Access Compliance Report

Public Rights-of-Way

(Curb Ramps)

Intersection ID: N/A	Main Street: POTOMAC_RIVER_PY	Cross Street: NATIONAL_AV	Location: W
ADA ID: F47FEC50CBD8	Ramp Type: Perp	Initial Pass/Fail: Fail	Overall Compliance: No
		Severity Score: 12.5

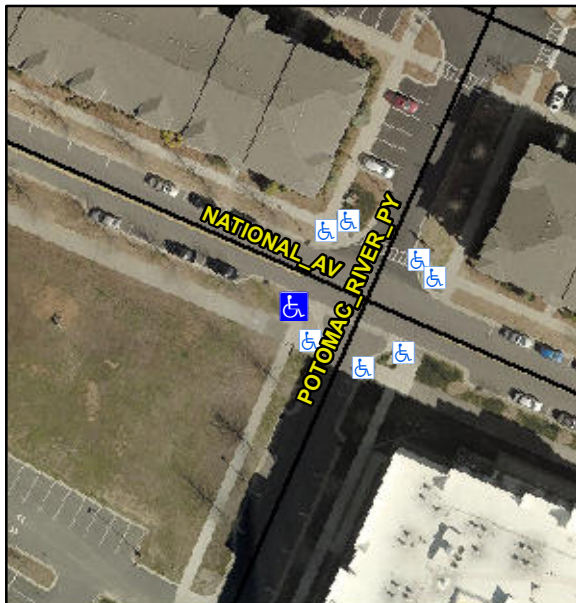
Not Found, R304.2.2

Compliance	Description	Data	Compliance	Description	Data
N/A	Ramp Length (in)	140.0	No	Ramp Slope (%)	10.8
Yes	Ramp Width (in)	55.0	Yes	Ramp XSlope (%)	0.8
N/A	Flare Type LT	N/A	N/A	Flare Type RT	N/A
N/A	Flare Slope LT (%)	N/A	N/A	Flare Slope RT (%)	N/A
N/A	Flare Traversable LT?	N/A	N/A	Flare Traversable RT?	N/A
N/A	Landing Length (in)	N/A	N/A	DWS Provided?	N/A
N/A	Landing Width (in)	N/A	N/A	DWS Contrast?	N/A
N/A	Landing Slope (%)	N/A	N/A	DWS Length (in)	N/A
N/A	Landing X Slope (%)	N/A	N/A	DWS Full Width?	N/A
N/A	Landing Curb? (Y/N)	N/A	N/A	DWS Offset (in)	N/A
N/A	Shared Landing?	N/A			
N/A	Gutter Ponding?	N/A	N/A	Gutter Slope (%)	N/A
N/A	Gutter Lip Ht (in)	N/A	N/A	Gutter X Slope (%)	N/A
N/A	Painted X Walk1?	No	N/A	Painted X Walk2?	N/A
	X Walk 1 Direction	To NE		X Walk 2 Direction	N/A
N/A	X Walk 1 Width (in)	N/A	N/A	X Walk 2 Width (in)	N/A
	X Walk 1 Slope (%)	4.6		X Walk 2 Slope (%)	N/A
	X Walk 1 X Slope (%)	2.9		X Walk 2 X Slope (%)	N/A

Remove & Replace Entire Ramp.
